BULLETIN!

ALL CarTeck Sectional Garage Doors now come with a revised top roller bracket!

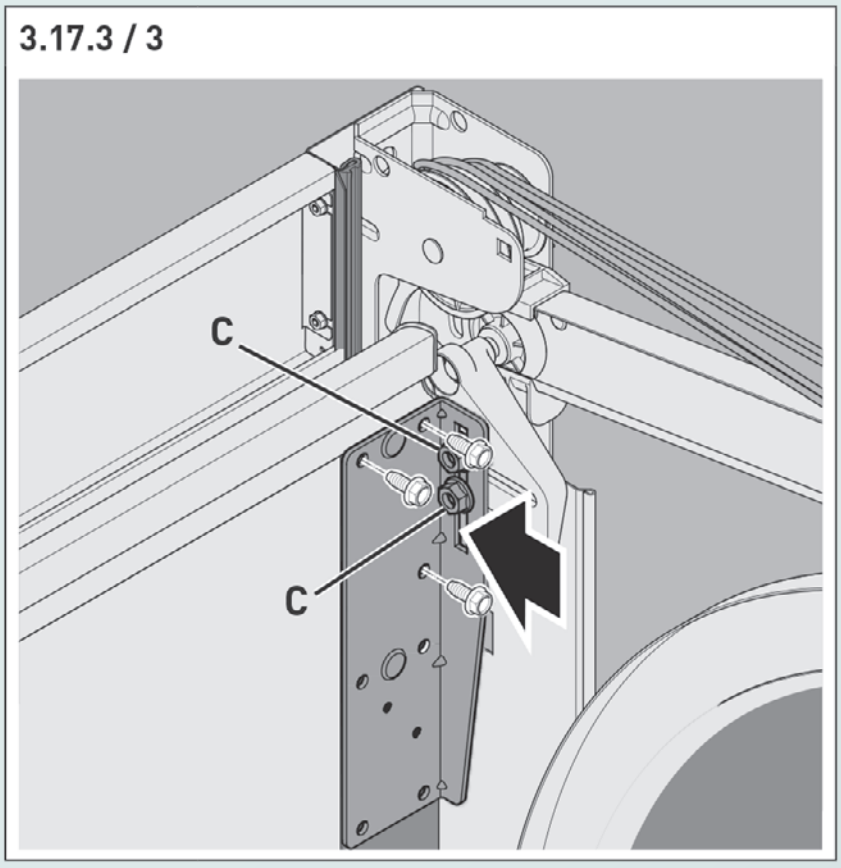
From the 30th October 2026, all CarTeck sectional garage doors will come with a revised top roller bracket. It probably looks familiar to you, as we are now standardising what was the 240mm headroom bracket on all doors!

See the image below for how to fit the bracket in the new orientation...

- Loosen the screws (C).
- Insert the roller of the top roller holder into the black plastic curved rail.
- Screw the left and right holding brackets for the top roller holder onto the upper door section.
